LOUIS ALLIS
Beloit Power Systems

Subject: Reference Telcon on 4/21/82 at 4:26 p.m.
Between Nick Jackiw of NRC and Rick Haisler,
Manager, Quality Assurance of BPS

Subject: BPS Generators Provided for Nuclear Standby Service -
Alternator to Spider Rotor Torque Value Discrepancies,
Hope Creek Alternator S/N 700510R2

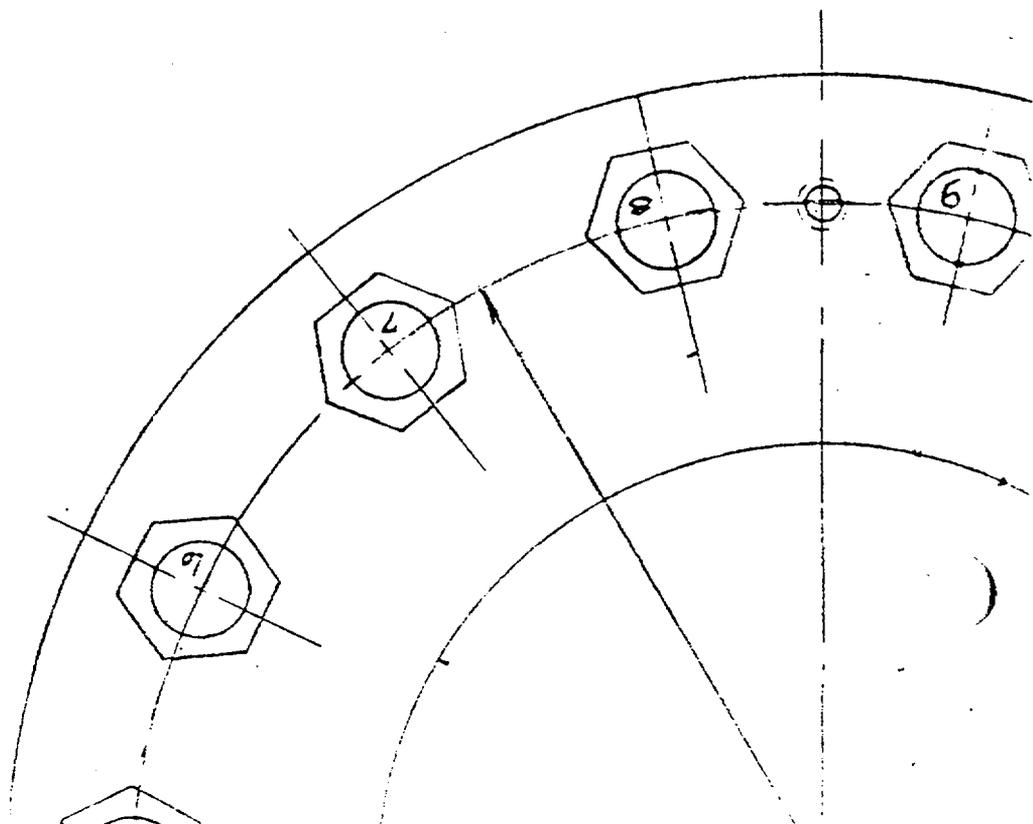
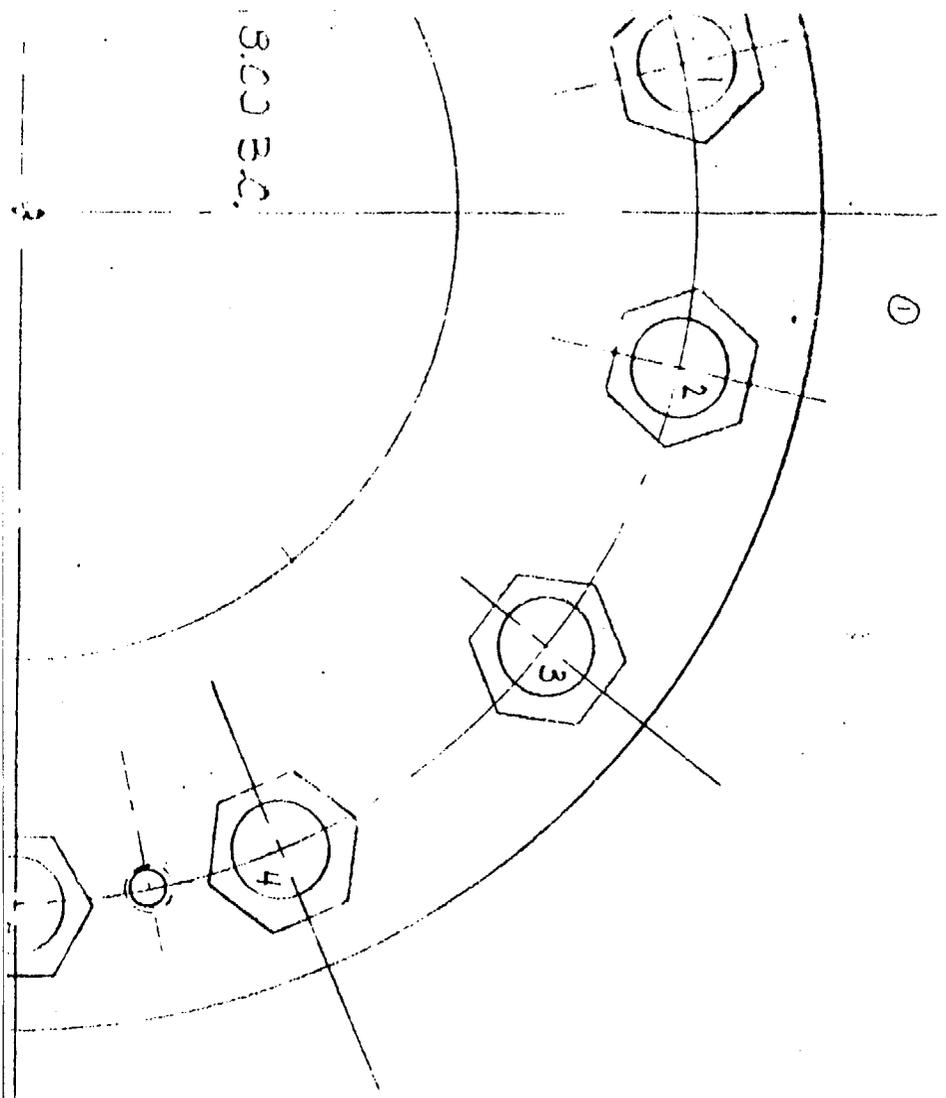
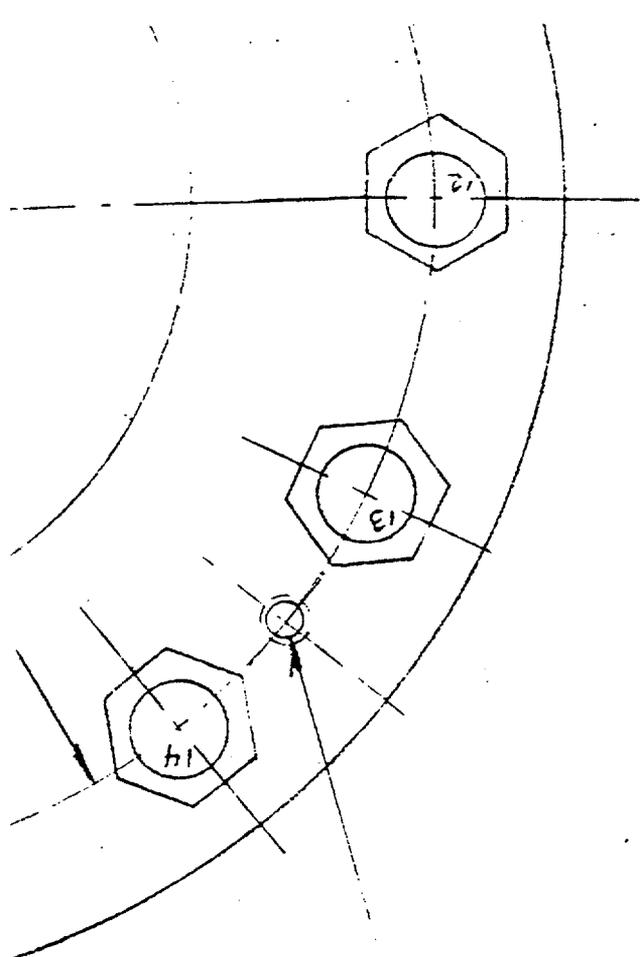
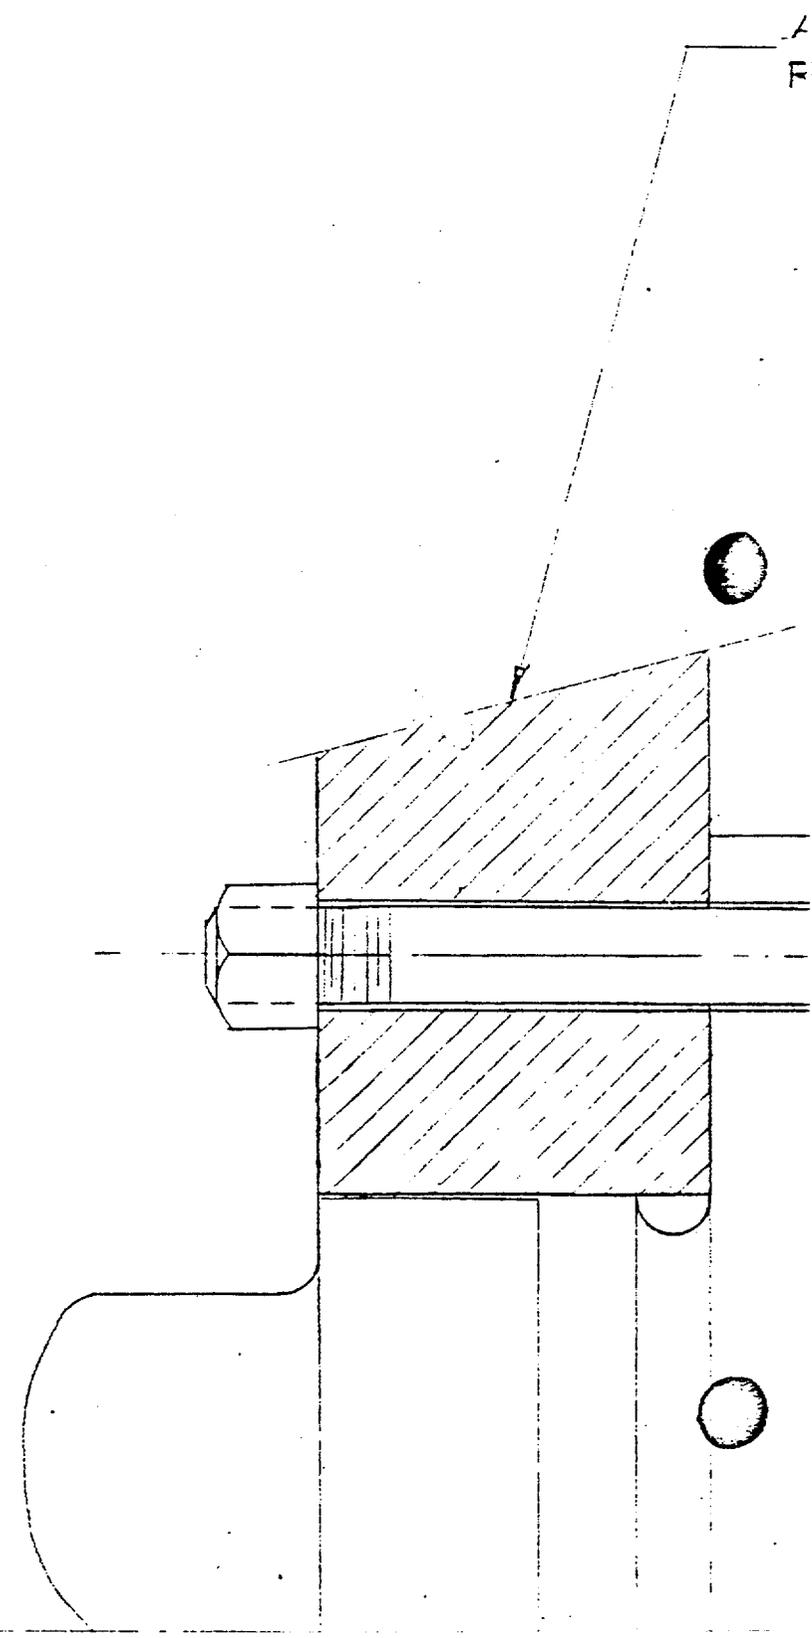
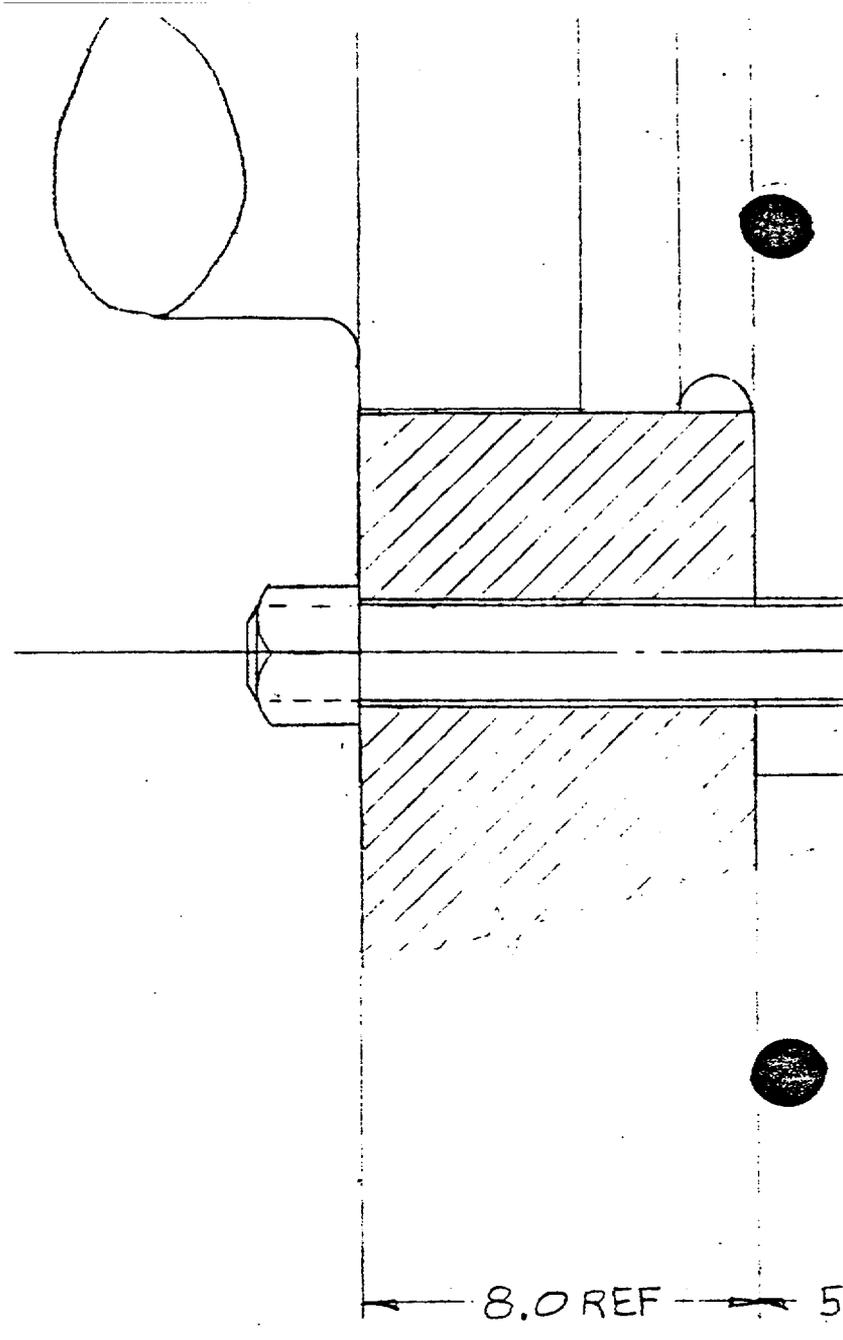
Colt performed a recheck of generator rotor to spider fastener torque values on March 12, 1982 to verify operation of newly designed tooling for use in the field. During this check, it was revealed that fastener #3 was not loaded at all while three other fasteners were only about 13% tight based on prescribed torque values. This revelation is not consistent with documentation presented to Colt, reference (b).

Colt is critically concerned about application of tooling used by BPS to physically torque the fasteners and determine torque values recorded on reference (b). Further, we feel that other BPS generators already shipped to the field could have latent defects with respect to improperly torqued rotor to spider fasteners. Defects of this nature must be reported under reference (a) regulations.

While estimating bolt load from the applied torque does not yield good accuracy, it is clear that the average load was not what it should have been. Even more disturbing is the one bolt that was not loaded at all and the three that were only about 13% tight. These 4 were certainly potential candidates for further loosening under operating vibration and load cycling.

The specification per 11 971 439 should have tightened all bolts to 4000 ft.lbs. Had this been true the average additional nut run-up would have been about 3/16 of one flat, only two moved this little.
